WEST VIRGINIA SUB-RECIPIENT APPLICATION HAZARD MITIGATION GRANT PROGRAM STRUCTURAL

NAME:	State EOC Hardening / Shelter
BUDGET:	\$5,000,000.00
Private Property	Demolition Removal (Participation Packet)
COMPLETED H	M GRANT APPLICATION
	ETTER OF 25% MATCH (if non-federal share is not available. Check with sitem)
	PROJECT TYPES
MITIGATION RE	CONSTRUCTION (Demo/Rebuild)
Desig	n to International Building Code 2009 or later.
Flood	Iplain, State and Local Ordinances.
Eleva	tion Certificate
Cons	truction Drawings (preliminary)
Maps	and photographs of project sites

The West Virginia Division of Homeland Security and Emergency Management (WVDHSEM) is proposing to structurally upgrade the existing Drill Hall located within the West Virginia National Guard Armory Building to create a community multi-use safe room for the State Emergency Operations Center (EOC). The Drill Hall is currently used for drill exercises and assemblies but is an ideal site for a safe room due to its size, open floor plan, and location outside of the special flood hazard area. The current state EOC is in the basement of the Capitol Complex Building One, approximately 3.5 miles from the proposed safe room site. Althoug

First Floor of Multi-Use Safe Room located at Charleston WVNG JFHQ on existing Drill Hall floor

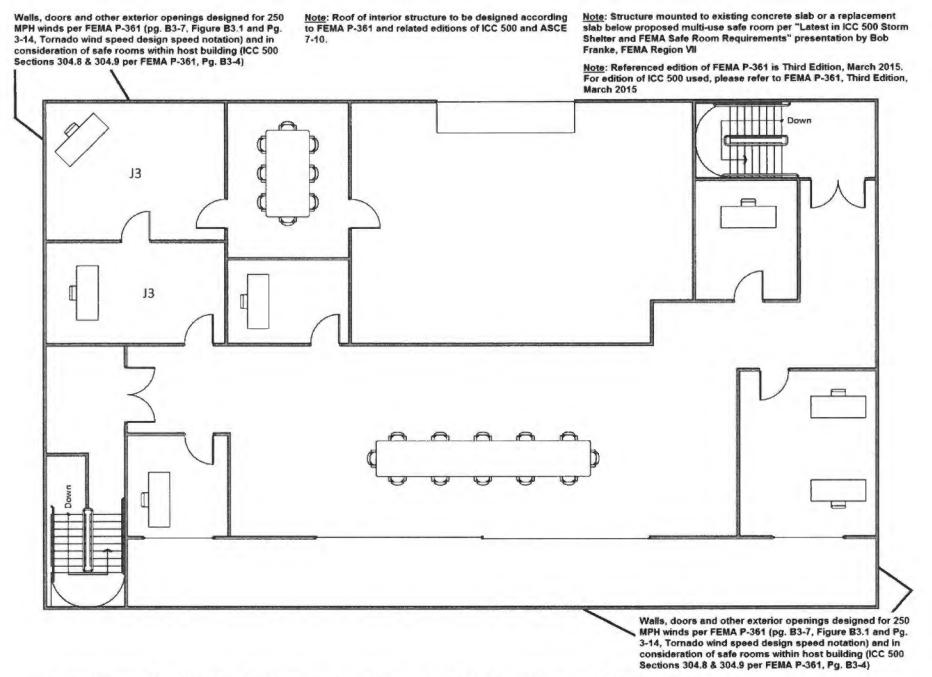
A preliminary conceptual layout of the proposed safe room has been provided by the subapplicant. The layout shows the existing space within the Drill Hall being converted to a two-floor multi-use safe room consisting of partitioned storage rooms, conference rooms, offices, and a large classroom or auditorium. Specific dimensions are not provided, but it appears the first-floor footprint is the same as that of the existing Drill Hall ($100 \text{ ft} \times 70 \text{ ft}$), while the second floor footprint is slightly smaller than this. The subapplicant should provide detailed dimensions for both floors, as this information is relevant to complete the benefit-cost analysis.

- The subapplicant should provide detailed overall dimensions for the first and second floors
 of the proposed safe room. This information is necessary to determine the gross floor area.

- The subapplicant should provide detailed dimensions for all partitioned spaces on the first and second floors of the proposed safe room. This information is necessary to determine the usable floor area. The usable floor area should be determined by subtracting from the gross floor area of excluded spaces, partitions and walls, columns, fixed or movable objects, furniture, equipment, and other items that cannot be removed or stored during use as a safe room. The usable area should not include unused spaces or areas that are normally locked, such as mechanical rooms, storage closets, or offices. Additional guidance for calculating the usable area can be referenced in FEMA P-361.
